Road Safety Audit Stage F Report (Part 2)

National Roads Authority
Galway City Transport Project
Road Safety Audit Stage F (Part 2)

Issue 2 | 3 September 2015

Figure 4: Proposed junction at Rahoan Road

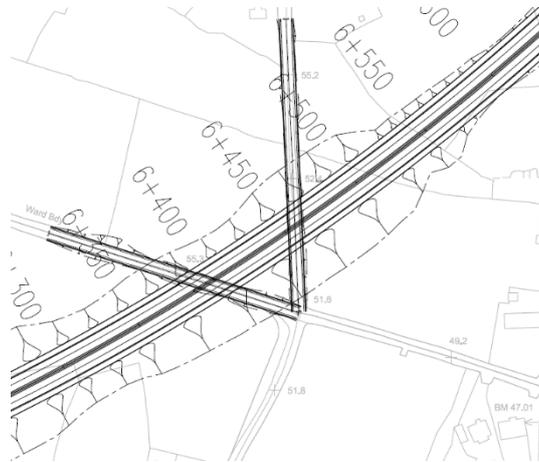
Issue: A crossroad type junction is proposed at Ragoon Road. The Auditors are concerned that junctions of this type can pose a serious collision risk to road users due to the see through issue. This junction may also be complicated due to the reduced visibility from the north as a result of the proposed underbridge. A junction of this type could potentially lead to sudden braking which could result in rear end shunt type collisions or may also lead to side swipe type collisions between passing road users.

Recommendation: The junction type should be changed to a staggered junction.

Problem	To be completed by Designer				Describe Alternative Measure	To be completed by Audit Team Leader	
	Problem Accepted		Recommended Measure Accepted			Alternative Measures Accepted	
	Yes	No	Yes	No		Yes	No
2.11	Y	-	Y	-		✓	
2.12	Y	-	Y	-		✓	
2.13	Y	-	N	-	The transition from single to dual carriageway has been relocated in the Preferred Route Corridor and now occurs at the location of the proposed roundabout at the Ballymoneen Road. This marks the transition from dual to single carriageway. Refer problem 2.6.	✓	
2.14	Y	-	Y	-	During Phase 3 Design, the scheme junction consistency shall be assessed with a view to minimising the number of variations.	✓	
2.15	Y	-	Y	-		✓	
2.16	Y	-	Y	-		✓	
2.17	Y	-	Y	-	During Phase 3 Design the junction layout will be examined and simplified as appropriate.	✓

Figure 5: Proposed N6 Interchange

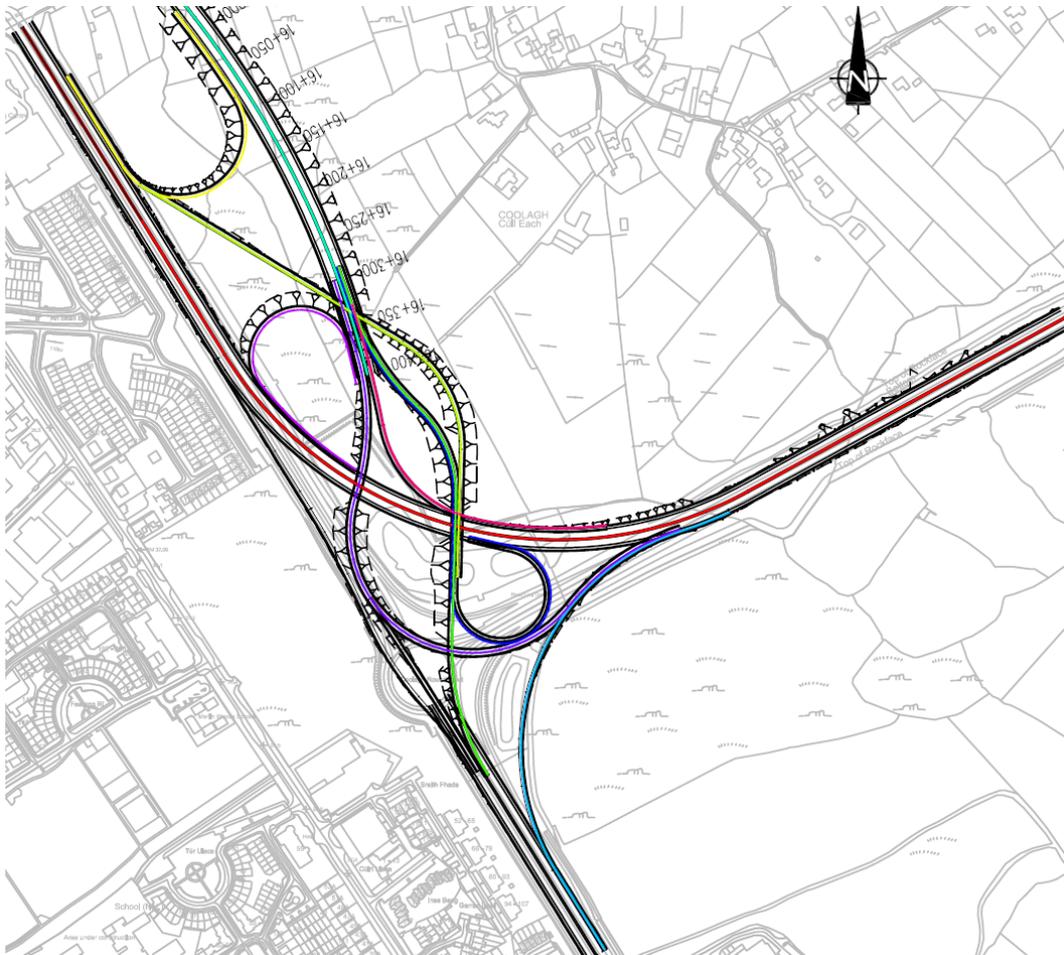
Issue A: The design presented for audit shows the existing N6 at Coolagh being realigned and terminating at the existing signalised junction at Briarhill (see figure 5 – red route). Road users will not expect the N6 to terminate at a signalised junction which could increase the likelihood of rear end shunt type collisions at this location.

Issue B: It is the Auditors opinion that the reduction of the expressway to a single lane in order to join the eastbound N6 (see figure 5 – pink route) could cause a collision hazard as road users will not expect the expressway to reduce to a single lane having travelled unobstructed for ~12km.

Issue C: The merge lane to the N6 westbound from the existing N6 (see figure 5 – yellow route) begins in close proximity to the signalised junction at Briarhill. This could increase the likelihood of rear end shunt or side swipe type collisions on the approach to the merge should a road user attempt to change lanes within the distance available.

Issue D: The merge lane to the N6 eastbound from the existing R446 (see figure 5 – purple loop route) is in close proximity to the expressway merge to the eastbound

N6 (see figure 5 – pink route). Successive merges such as these can pose collision risks to road users on the N6 mainline as well as those joining the N6 mainline.

Issue E: The Auditors are unsure as to how the proposed expressway link to the R446 south, proposed expressway link to the N6 west and proposed N6 at Briarhill to the R446 south (see figure 5 – green, dark blue and lime green routes) will operate as the design includes various lane gains, lane drops and level differences. A combination of all of these factors could prove confusing for road users which could increase the likelihood of collisions throughout the interchange.

Issue F: The design of the R446 northbound merges with the westbound expressway (see figure 5 – purple route) and northbound N6 (see figure 5 – red route) do not appear to have been completed and the merge with the purple route appears to be quite severe and on a curve.

Recommendation: The design of the N6 free flow junction should be readdressed in order to minimise its complexity and to decrease the potential confusion that may be caused to road users.
